Staff Reviewer Staff Recommendation **Zone Change 2007Z-052U-14**

Wello Planning C	ommission weeting of 4/26/2007
	difference is that in OL, parking may be placed in front of the building. Staff does not recommend approval of OL zoning solely to permit parking in front of the building. Parking in the front of the building and at the entrance of a residential neighborhood would not be a desirable situation.
Staff Recommendation	Staff recommends disapproval because the request is inconsistent with policy.
RECENT REZONINGS	A request to rezone the southern parcel from R10 to OR20 was approved by the Planning Commission on August 10, 2006. A request to rezone a parcel one block north of this location from R10 to OL was approved by the Planning Commission on April 12, 2007 (2007Z-050U-14).
PUBLIC WORKS

Planned Unit Development 90P-019U-13 Vale Ridge

Zone Change 2007SP-057G-12 Christiansted Park SP

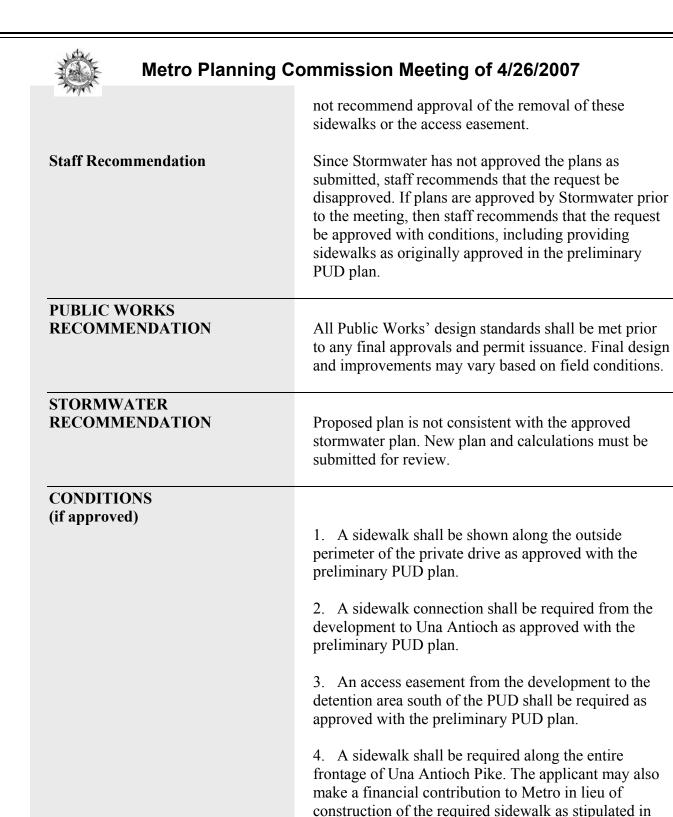
Disapprove unless Stormwater approves stormwater plans prior to the meeting. If stormwater plans are approved prior to the meeting, then staff recommends

The plan as submitted is generally consistent with the last approved preliminary PUD with the exception of some minor building shifts. A significant difference is the removal of the sidewalk along the outside perimeter of the private drive, the removal of the sidewalk from the development to Una Antioch Pike, and the removal of the access easement from the development to the detention just south of the PUD boundary. Staff does

Zone Change 2007SP-064U-14 Price's Collision SP

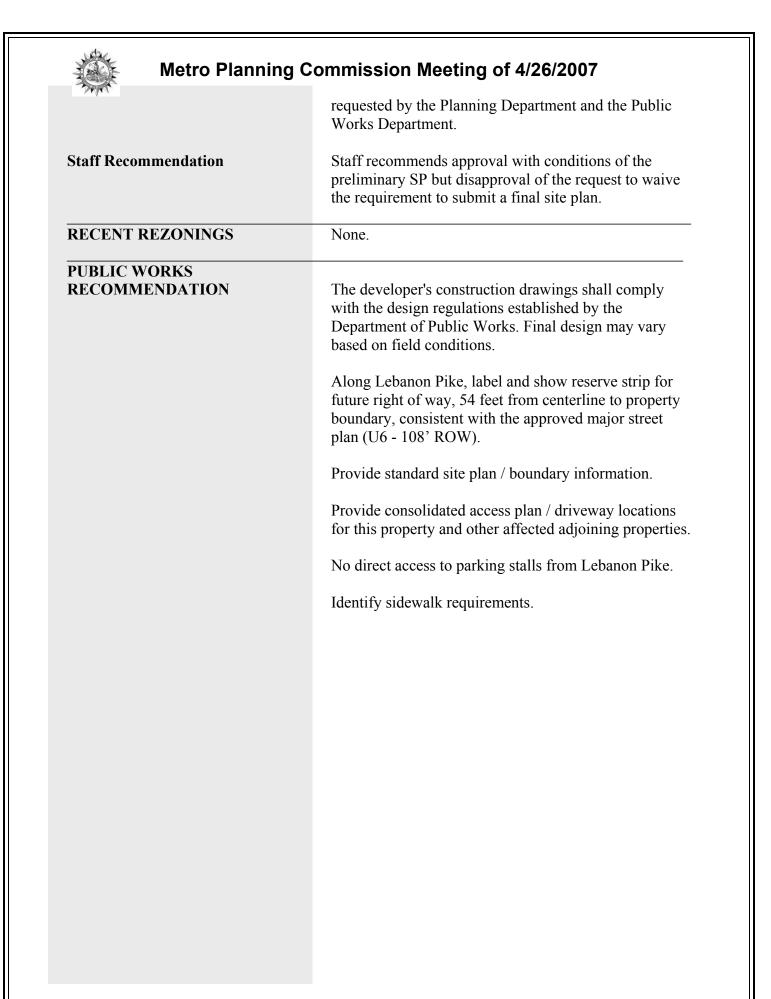
27 parking spaces are proposed. The location of the spaces have not been included on the plan.

The SP, as submitted, does not have sufficient detail that the submittal of a final site plan would essentially duplicate the applicable portion of the approved development plan. The missing details relate to access management, sidewalks, and the reserve strip along Lebanon Pike for future right-of-way that have been

- 8. There shall be no direct access from Lebanon Pike to the parking stalls in front of the building; access shall be from a driveway.
- 9. Provide details showing access and changes to existing conditions to control the access from Lebanon Pike.

- 10. Along Lebanon Pike, label and show reserve strip for future right of way, 54 feet from centerline to property boundary, consistent with the approved major street plan.

- 11. Identify the location of the parking spaces on the site plan.
